Groundwater Transfer Review Summary Form

Transfer/PA # T- 14650

Application: T-14650

Applicant Name: City of Independence

Well Interference Analysis (Theis, 1935):

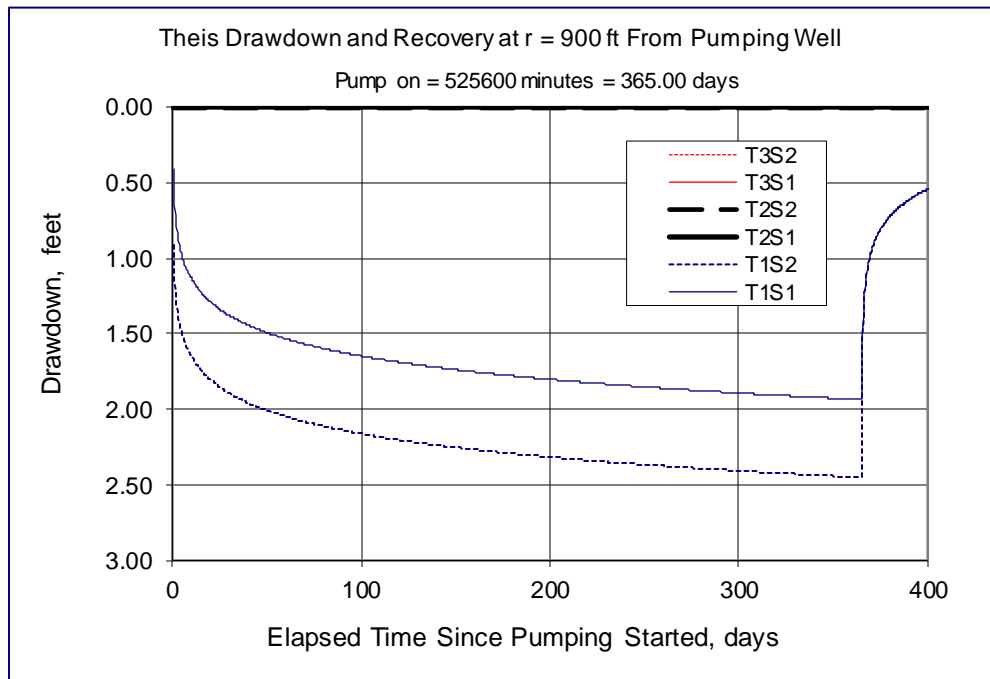
☒ Yes ☐ No Comments: **Claim: GR 422** (Priority Date: 6/1/1952) is the nearest another groundwater right, located ~900 ft north of the proposed APOA (POLK 2945). POLK 2944 appears to be an authorized POA under **Claim: GR 422**. POLK 2944 is ~2,300 ft north-east of the authorized POA, POLK 53003. A decrease in intervening distance will likely result in an increase in interference with the neighboring well POLK 2944.

☐ Yes ☒ No If yes, explain: Potential interference with POLK 2944 from the proposed changes were evaluated using the Theis (1935) solution for drawdown in a confined aquifer (see attached Well Interference Analyses). The results indicate that the proposed changes are unlikely to injure neighboring groundwater rights.
